MI&CT eSERVICE NOTE
SN0803070720a

Subject: Collimator Cam Motor FRUs

Effectivity: VCT systems

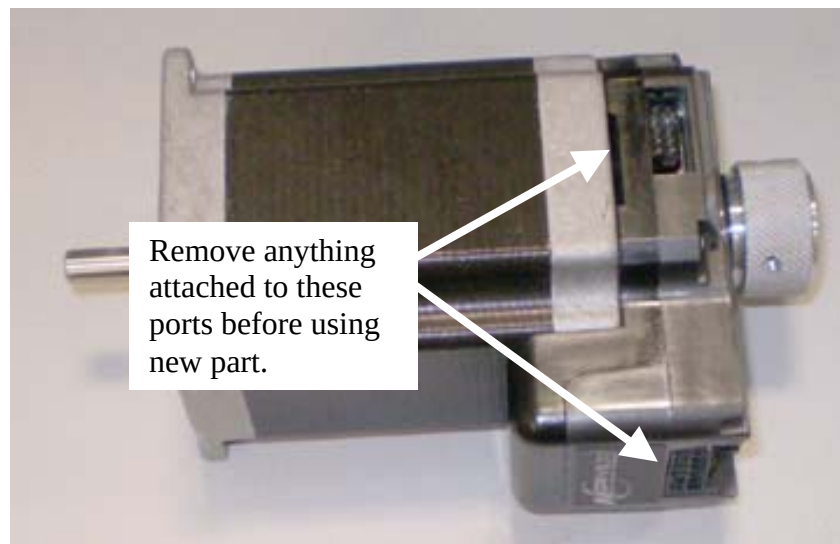
One older version of the collimator cam motor FRU has a small circuit board attached to the power plug of the cam motor when shipped as a replacement part. This small circuit board is for shipping purposes only to provide a back potential to keep the motor from spinning during shipping and handling. It is not part of the system design.

Remove the small circuit board and discard it, it is only for shipping purposes for one version of the cam motor. The small circuit board is not used on the collimator. This notation will be added to the replacement procedure.
